MEMORANDUM

TO: Outagamie County Agriculture, Extension Education, Zoning & Land Conservation Committee
FROM: Isaac Uitenbroek, Zoning Administrator
DATE: June 2, 2025
RE: **PL202500149; Special Exception – Large-Scale Solar Energy System**

New London Solar Project

SHEET TITLE:
DEVELOPMENT LAYOUT

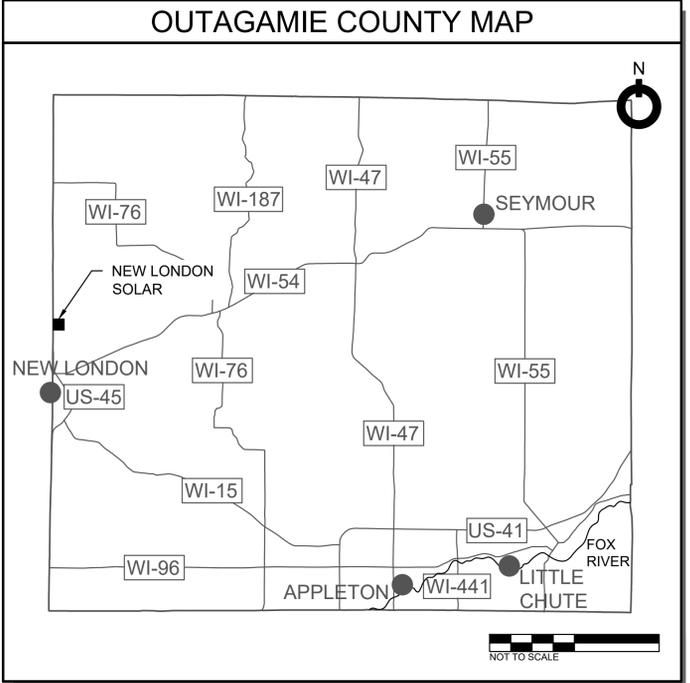
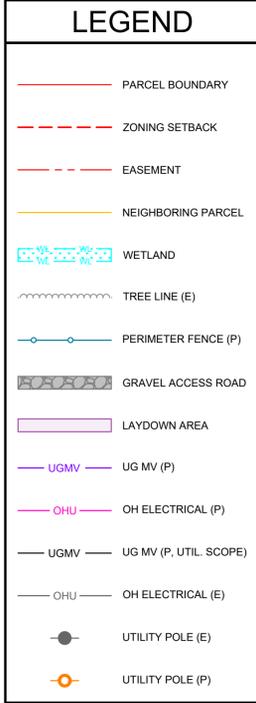
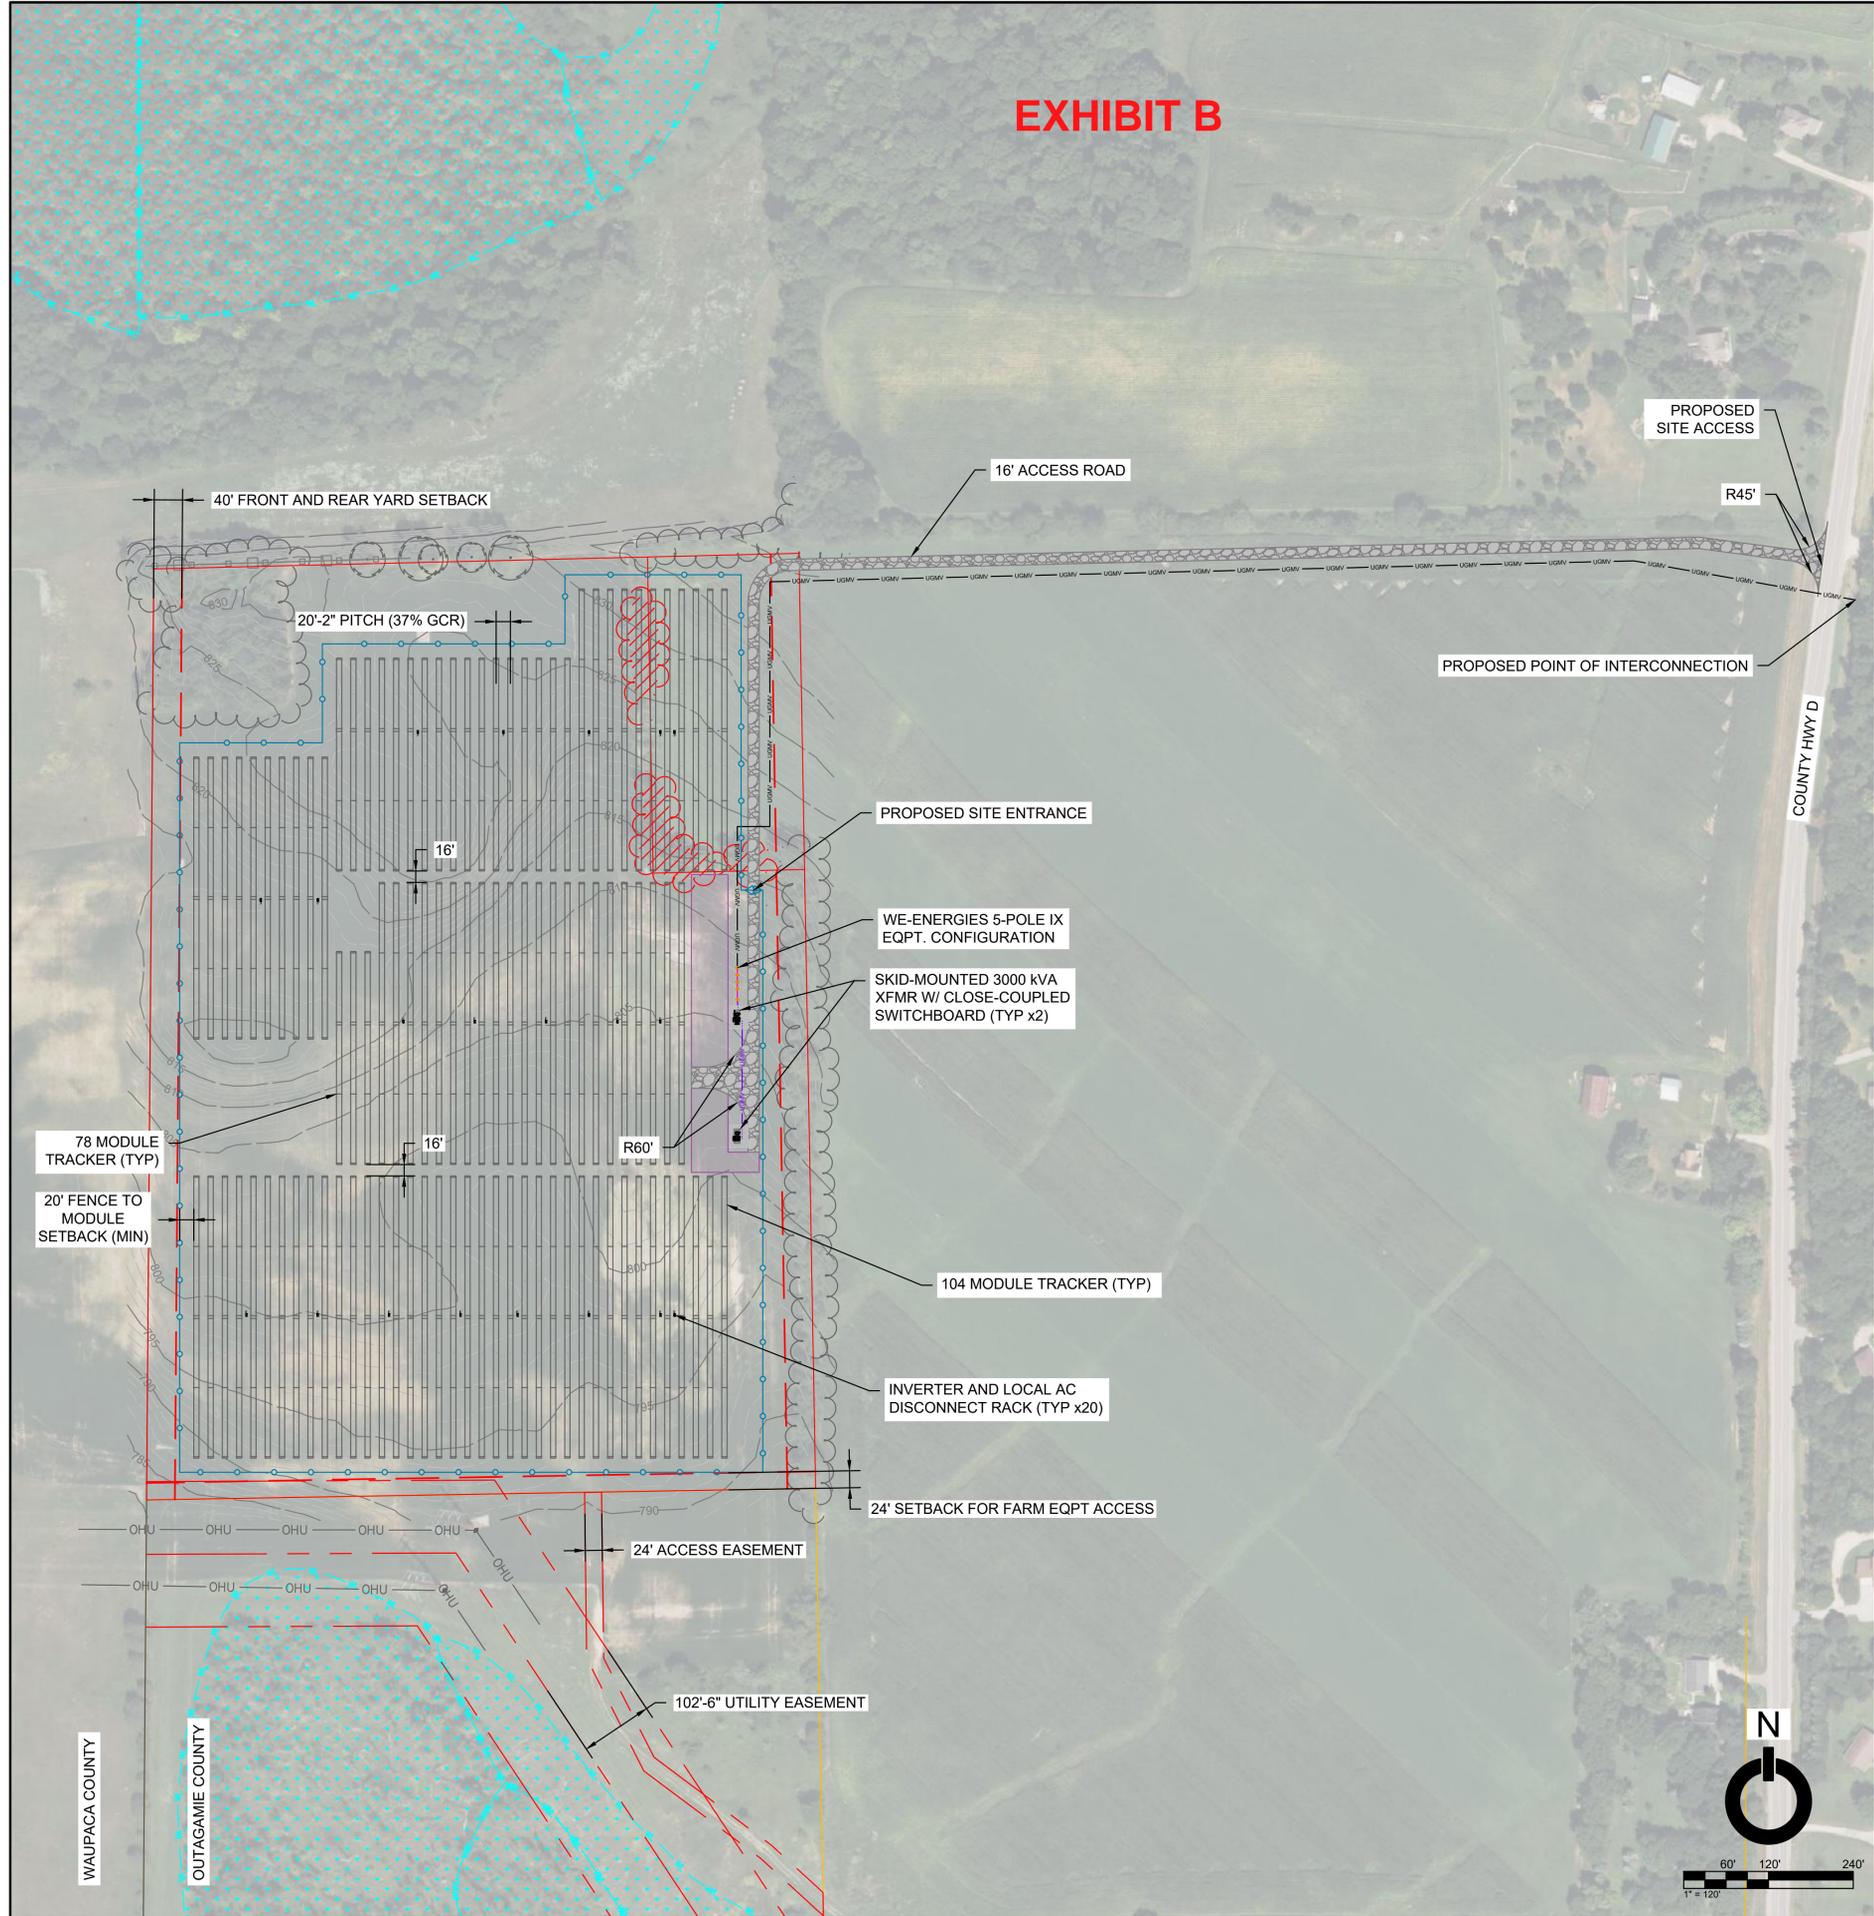
- **Staff Analysis:** *Satisfied. Per the site plan (see Exhibit B) required setbacks will be met for the arrays. There is no BESS proposed.*
